Response to Request for Additional Information
Holtec International
Docket No. 71-9325
HI-STAR 180 Transportation Package – LAR 9325-1

Licensing Drawings

Figure 2-4.1: Typical Loading/Unloading Curve for Metallic Seals

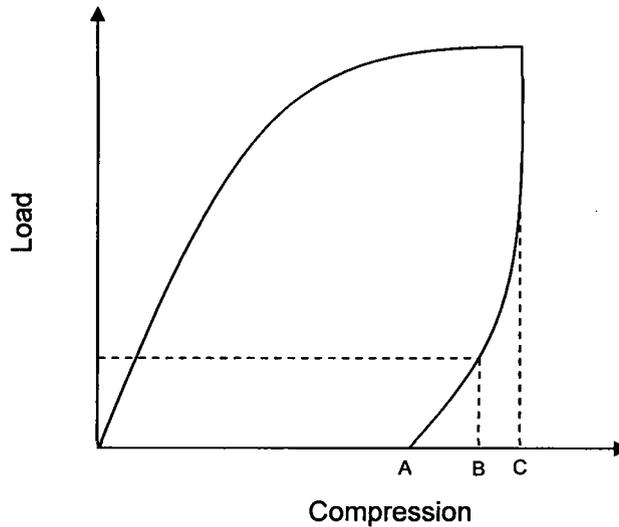
- 2-4 Explain the difference between "useful spring-back" and "total spring-back," and the meaning of "fix," as used in the justification for change.

The application states that "useful spring-back" is now used instead of "total spring-back" to clarify the required seal performance and that the information presented in Appendix 4.A, as well as in the drawings, together "fix" the seal joint design.

The difference between "useful spring-back" and "total spring-back" is illustrated below in Figure 2-4.1 below. Total spring-back (which is measured from point C to point A in Figure 2-4.1) refers to the elastic recovery of the seal when the load on the seal is reduced to zero (i.e., complete decompression of seal). Useful spring-back (which is measured from point C to point B in Figure 2-4-1) is established by the seal manufacturer, and it indicates the amount of spring-back that the seal can sustain without compromising its performance (i.e., measured leakage rate remains below leakage rate limit). Useful spring-back typically corresponds to the elastic recovery of the seal when the compression load on the seal reduces to 20% to 30% of its maximum seating load.

The word "fix" was used in the Summary of Proposed Changes (SOPC) to connote that the seal joint design is not variable. That is to say the licensing drawings, together with the information in Appendix 4.A, fully define the seal joint design. In particular, Appendix 4.A defines the specific seal manufacturers and part numbers that are to be used with the HI-STAR 180 cask.
